AP Procurement Engineering Storage - ODD

HLDS GSA-T50N, UltraSlim Enhanced SATA
Multi-Burner (Rambo) (P/N:43W4636)

Misleading Bezel icon

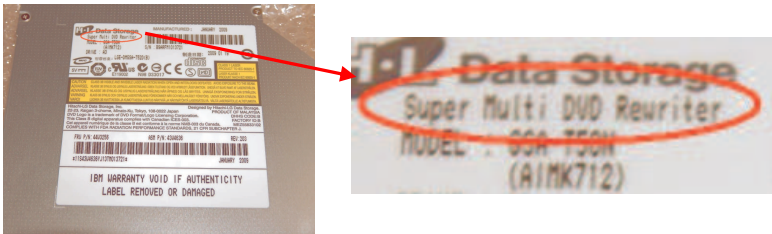
Description of ODD says "Super Multi DVD Rewriter", but icon on the front bezel shows "CD Rewrite" and DVD Multi player" function indicating that the drive can only read DVD, but cannot write. This could be misleading to the customer, because the ODD actually can write/rewrite DVD media, so the ODDs are functionally OK. Find pictures below.

DRIVE LABEL shows "Super Multi DVD Rewriter" which is correct.

DRIVE Bezel shows "CD ReWritable" & "DVD Multi player", these indicate drive has only read DVD function, but cannot write which is **INCORRECT**. The drive indeed has a DVD write function.

Expected icon look like this

HLDS drive (IBM PN: 43W4636) which has the misleading bezel icon

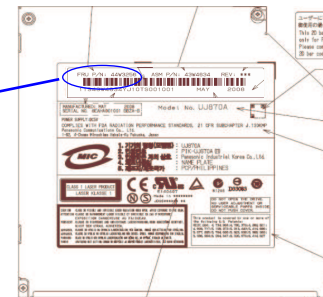
Share same
FRU
PN:44W3256

- Hence we need to find out the qty, location of the FRU PN: 44W3256 WITH ASM PN: 43W4636

FAI template

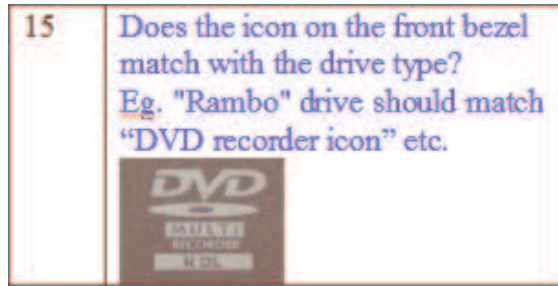
- Improve First Article Inspection report to check the accuracy of bezel icon.
